an application for approvals by Matakanui Gold Limited to establish, operate, rehabilitate and ultimately close an open pit and underground gold mining operation known as the Bendigo-Ophir Gold Project

Memorandum of Counsel on behalf of Matakanui Gold Limited responding to Request for Information on Hazardous Installations

Environmental Risk Assessment – Process Plant, Bendigo Ophir Gold Project, Central Otago

(Our Reference: 31357.000.001_03)

Figure 2: Process Plant Layout (as of June 2026). Images provided by MGL

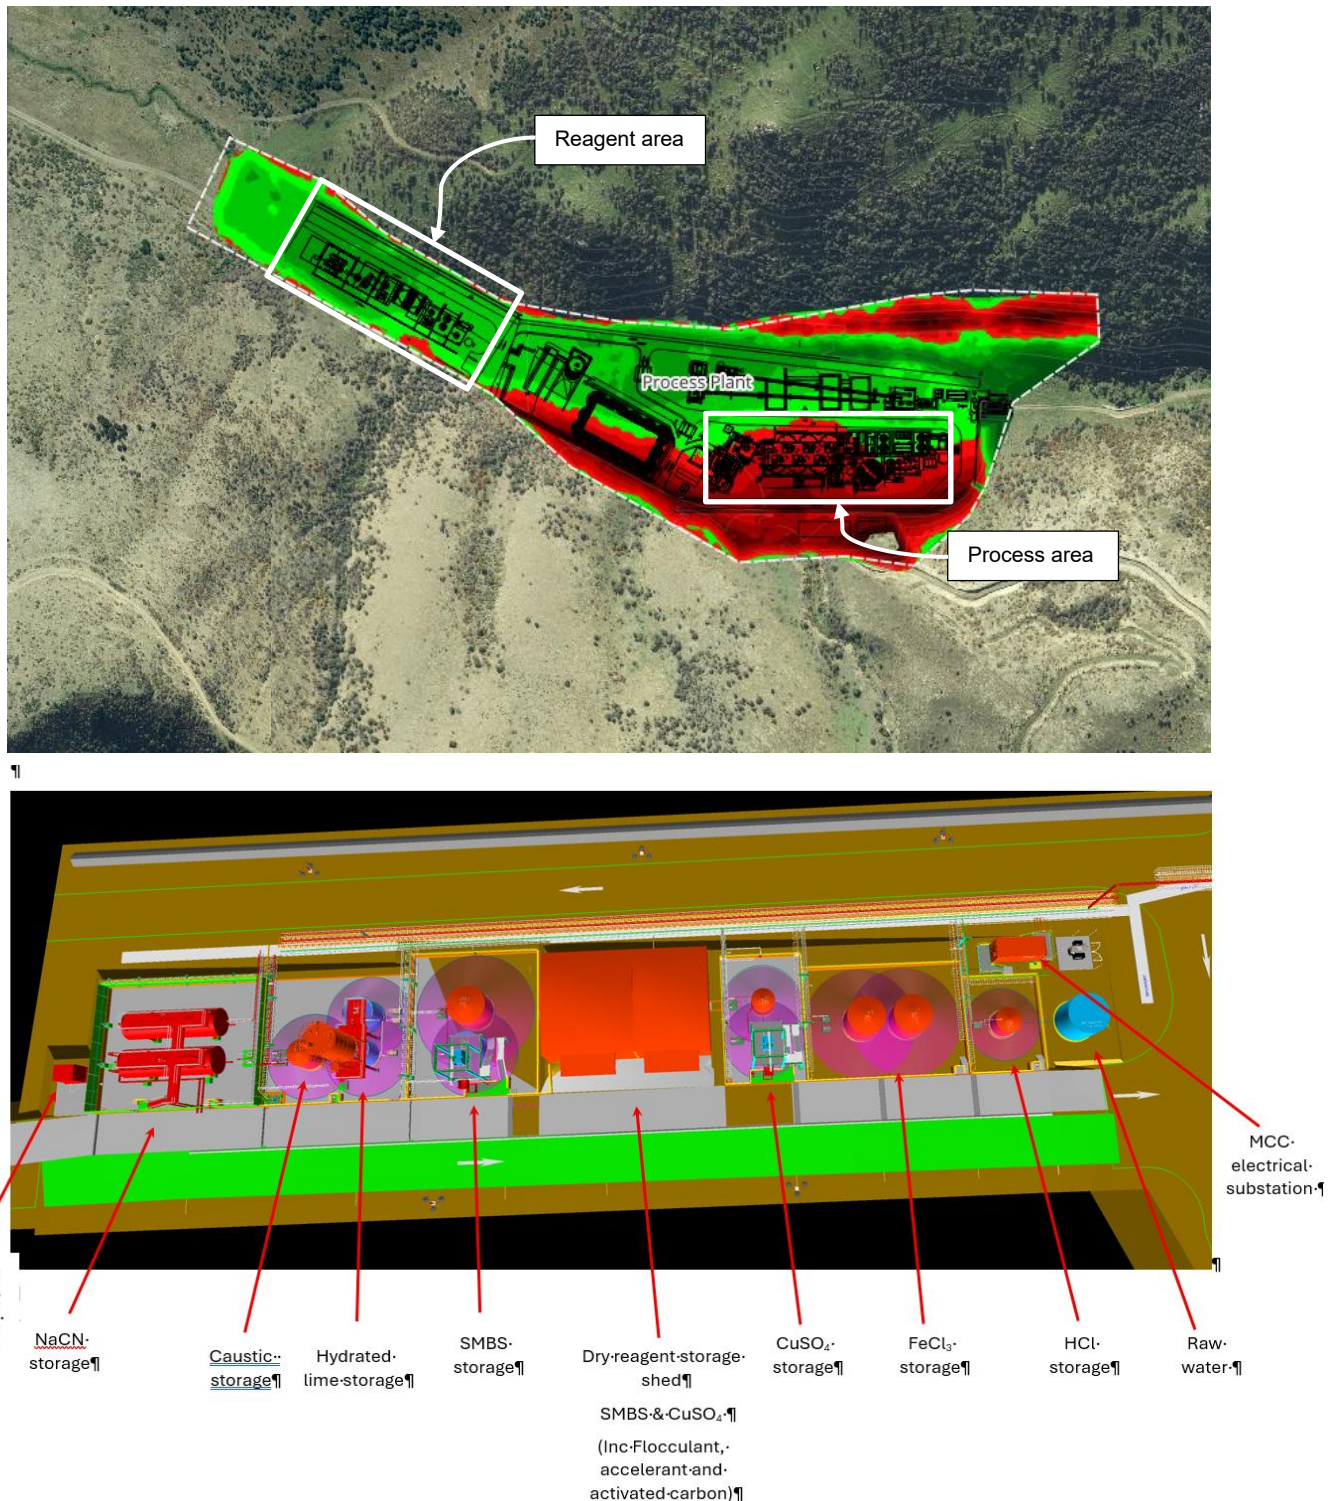
- A Reagent Area. Individual reagents will be stored separately in dedicated bunded areas. The bunds will be designed to contain 110% of the largest tank volume within that area and designed to comply with the crest locus limits (shown by the pink shadows on Figure 2). The area also includes a dry reagents storage shed.

The site layout has been designed so that the Process Plant is located at a significant distance from locations where explosives are stored and used. Within the Process Plant area itself, the Reagent Area, has been located at the 'downstream end', with the gold processing plant and ROM pad upstream, closer to the mining activities. This means the trucks delivering chemicals enter as small a part of the Process Plant area as possible whilst vehicles carrying ROM generally don't need to pass the Reagent Area. This reduces both the risk of vehicle-on-vehicle collisions and the potential for vehicle damage to hazardous substances storage tanks.

The reagent storage is located on a concrete slab with individual bunds for all substances except caustic soda and hydrated lime, which will be together as they are compatible substances. All the bunds have been sized so that they can contain a volume of at least 110% of the volume of the largest tank contained. All bunds are fitted with a level monitor which triggers an alarm if the level of liquid in the bund reaches a certain height. An operator will visit the relevant bund and assess if the liquid in the bund is rainwater or spilled chemical and manage it accordingly. All bunds have a sump pump to enable the removal of spills or stormwater.

All tanks in the Reagent Area are individually bunded (except caustic soda and hydrated lime which can be stored together as they are compatible substances). The tank bunds have a volume of at least 110% of the volume of the largest tank contained.

Figure 3: Regional Geological Setting (GNS webmaps)

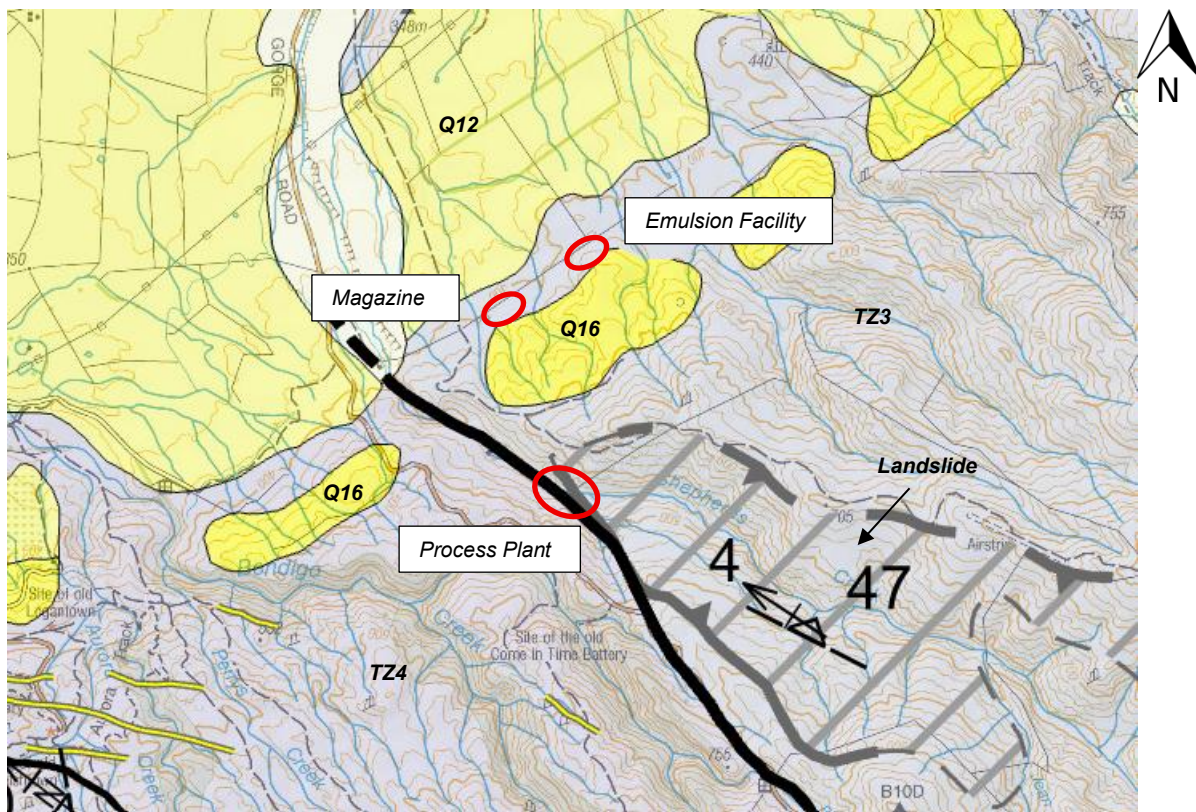
As indicated on Figure 3, the bedrock geology at the site generally comprises Permian to Triassic era Haast Schist (Rakaia Terrane). The inactive Thompsons Gorge Fault is mapped by GNS (GNS Science, 2020) along the lower part of Shepherds Creek separates Textural Zone (TZ) units TZ3 and TZ4. TZ3 schist is found to the northeast of the fault and comprises undifferentiated pelitic and psammitic schist and greenschist sequences. TZ4 schist is found to the southwest of the fault and has similar geology to TZ3. In broad terms, from a geotechnical perspective, stability in TZ3 is typically foliation controlled, which TZ4 has more complex behaviours.

A large scale landslide is indicated by GNS on the slopes to the north and west of the proposed process plant. We consider that this is a dormant / relict feature and provide further comment in Section 5.5.2.

FIGURE A1.1 – INTERPRETED GEOHAZARD MODEL

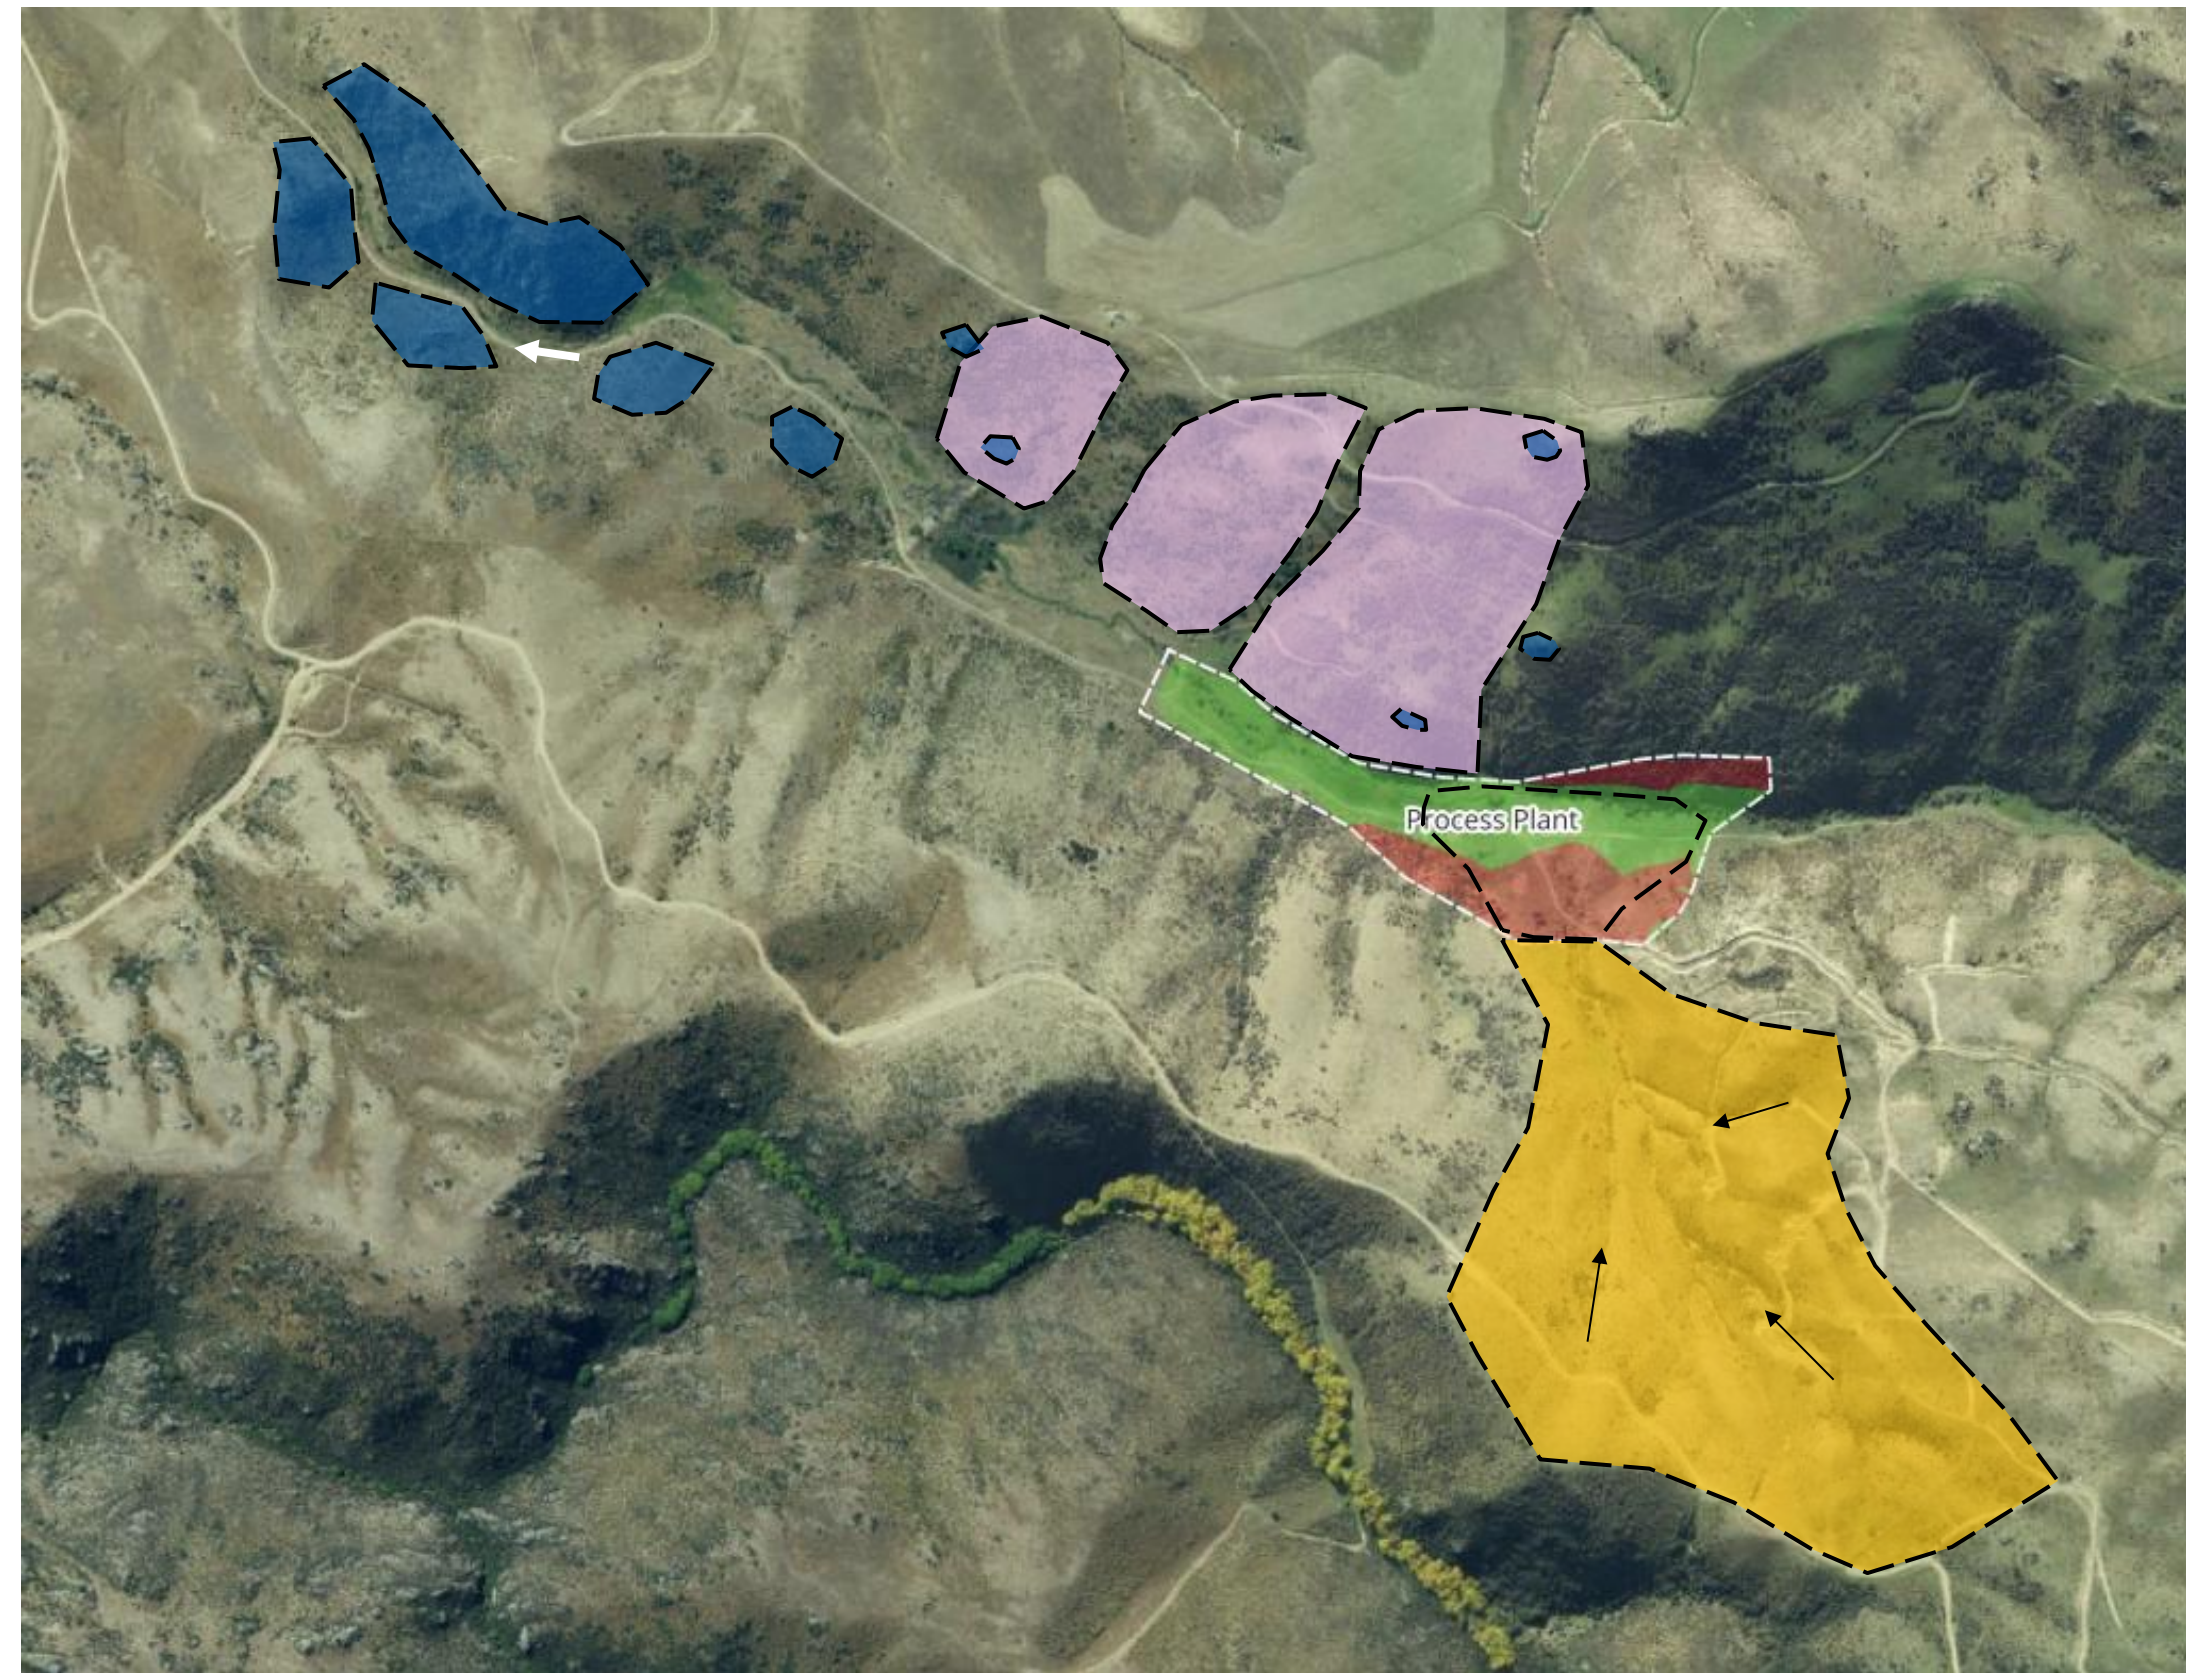
As outlined in Section 5.3, the Process Plant is in relatively close proximity to a number of slope instabilities, outlined as follows:

1. **Deep – seated landslides from the Northern Slopes.** Whilst relatively large scale, these landslides appear to be inactive – relict, and it is likely that they have an age range on the order of thousands to 10s of thousands of years. They therefore have very likely experienced several large magnitude earthquakes (such as Alpine Fault movement), with no evidence of significant movement observed.

2. **Rockfall.** Isolated rockfall sources were identified on the northern slopes above the Process Plant. However, field observations suggest (a) these rocks are released infrequently and (b) have low kinetic energy, such that they do not travel far across the valley floor. As the Reagent and Process areas are located on the distal (southern) side of the Process Plant from the identified areas of rockfall, and that the plant will also be raised from current topography, it is considered very unlikely that rocks would reach either of these areas, and more unlikely again that they would have significant energy to rupture any tanks present.

3. **Debris Flow from the gully adjacent to the CIT Pit:** A notable alluvial fan extends from the prominent side gully to the west of the proposed CIT pits into the main gully of Shepherds Valley. In addition, evidence of small-scale debris flow is apparent in recent aerial photography and during our site reconnaissance. We consider that the catchment is not large enough to generate sizeable debris flows, and in addition, the CIT Pit will redirect some of the runoff from this catchment. However, for risk assessment purposes, we have conservatively assumed that a debris flow large enough to cause significant inundation into the area of the Process Plant may have a return period of between 50 and 100 years.

- **Medium** must be avoided or mitigated proportionate to the level of risk. In this case, we consider that the expected relatively small debris flows that may occur down the catchment to the west of the CIT Pit can be readily dealt with in the civil design that will be required for the Shepherds Gully Service Corridor. Appropriate mitigations could include:
 - i. Increasing the design capacity of clear water structures to allow for sediment laden flow, or
 - ii. Construct a catch fence or grizzly screen upstream of the Process Plant to catch coarser particulate.
- **Low** can be accepted without risk mitigation.

- To avoid potentially exceeding the bund capacity for sodium cyanide (and the resulting discharge of diluted sodium chloride) in the unlikely event that both the water and sodium cyanide tanks fail simultaneously, it is recommended that the water tank is generally kept empty. We recommend it is only filled when a sodium cyanide delivery is imminent. This could be offered as a condition of consent.
- Undertaking modest engineering works as part of the design of the Shepherds Valley Corridor to reduce the consequence of future debris flows from the catchment to the west of the CIT Pit. Possible mitigation options are described above.
